### Gateway determination report

<b>LGA</b>	City of Parramatta
<b>PPA</b>	City of Parramatta
<b>NAME</b>	286-300 Church Street Parramatta (318 dwellings, 172 jobs)
<b>NUMBER</b>	PP_2018_COPAR_008_00
<b>LEP TO BE AMENDED</b>	Parramatta Local Environmental Plan 2011
<b>ADDRESS</b>	286-300 Church Street Parramatta
<b>DESCRIPTION</b>	Lot 1 DP128501, Lot 5 DP516126, Lot 1 DP210616, Lot 2 DP216665, Lot 100 DP803945 and Lot 1 DP84998
<b>RECEIVED</b>	08 June 2016
<b>FILE NO.</b>	IRF18/3154
<b>POLITICAL DONATIONS</b>	There are no donations or gifts to disclose and a political donation disclosure is not required
<b>LOBBYIST CODE OF CONDUCT</b>	There have been no meetings or communications with registered lobbyists with respect to this proposal

**Figure 5:** 10m/12m setback of tower when viewed from Church Street (Source: Urban Design Report – PTW)

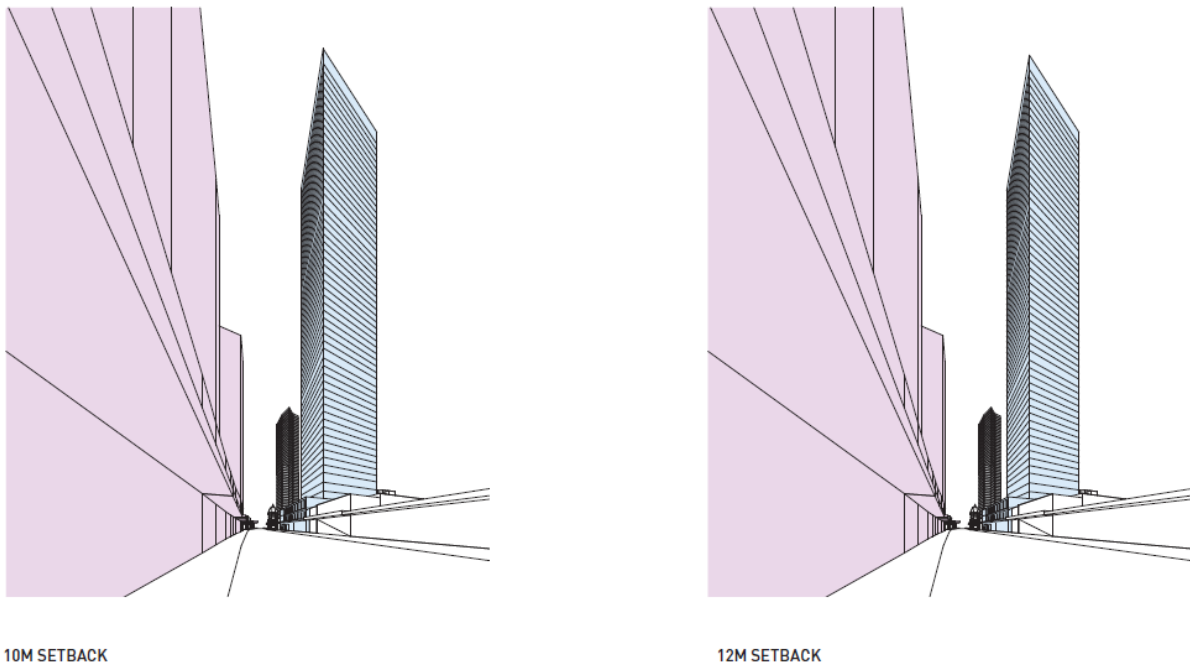
The current controls require a 18m setback, for development over 12m in height, from Church Street. The planning proposal has proposed to reduce the setback to 10m on the basis that the CBD planning proposal seeks to reduce the setback to 12m and the perceptible difference between 12m and 10m (i.e. 2m) when viewed from the street level is negligible. **Figure 5** below identifies the reference design with 10m and 12m setbacks when viewed from the southern end of Church Street. It is noted that the CBD Gateway determination requires that the existing controls be retained for Church Street unless further investigations relating to urban design, heritage and commercial feasibility are provided.

Whilst it is agreed that the difference of 2m is difficult to perceive when viewed from Church Street the difference from the original setback of 18m to 10m would be readily detectable. In this respect, the 10m setback is not currently supported.

In order to resolve issues with the tower setbacks and podium heights whilst ensuring consistency within the locality as a whole, a condition has been recommended in the Gateway determination that the proposal is consistent with the CBD planning proposal outcomes and a revised design reference be submitted.

**Figure 7:** Design Option D (source: Urban Design Analysis)

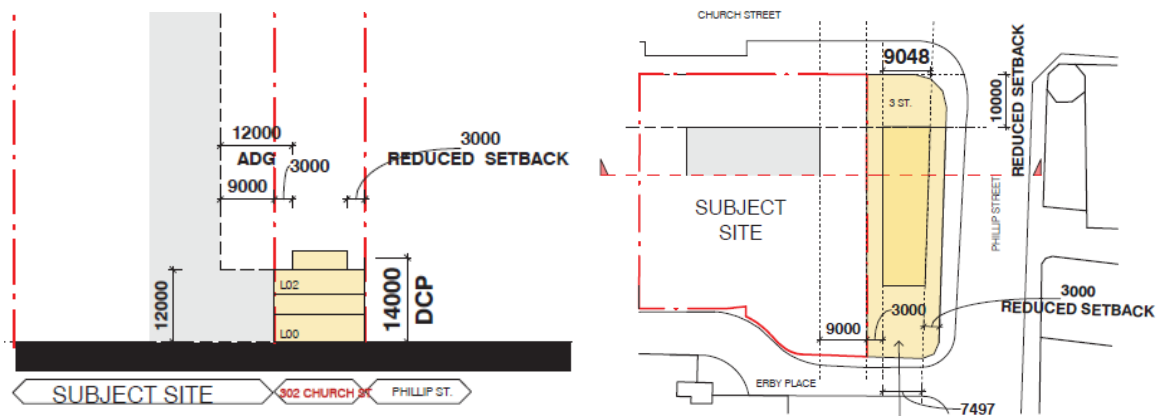
isolation. It is evident from the options that a tower is not possible within 302 Church Street in isolation. The preferred option (**Figure 7**) identified by the Urban Design Reference is extremely limited in development potential, with a low height (four storeys) and small floor plate (less than 250m<sup>2</sup>) when taking into consideration the Apartment Design Guidelines and DCP setbacks.

Furthermore, the preferred option assumes non-compliance with the DCP with respect to setbacks and as such if compliant setbacks were identified in the design the development potential would be even less. Should the planning proposal proceed without 302 Church Street it would effectively isolate the site and limit the development potential to a large extent.

In this instance it is considered appropriate that the planning proposal be extended to include 302 Church Street and it is recommended that the Gateway be condition accordingly. Only with the inclusion of 302 Church Street as part of the planning proposal will a consistent planning framework be put forward for the locality in an orderly manner. Once rezoned, should the owners of 302 Church Street not want to develop their land in the future it can be dealt with under any future development application process.
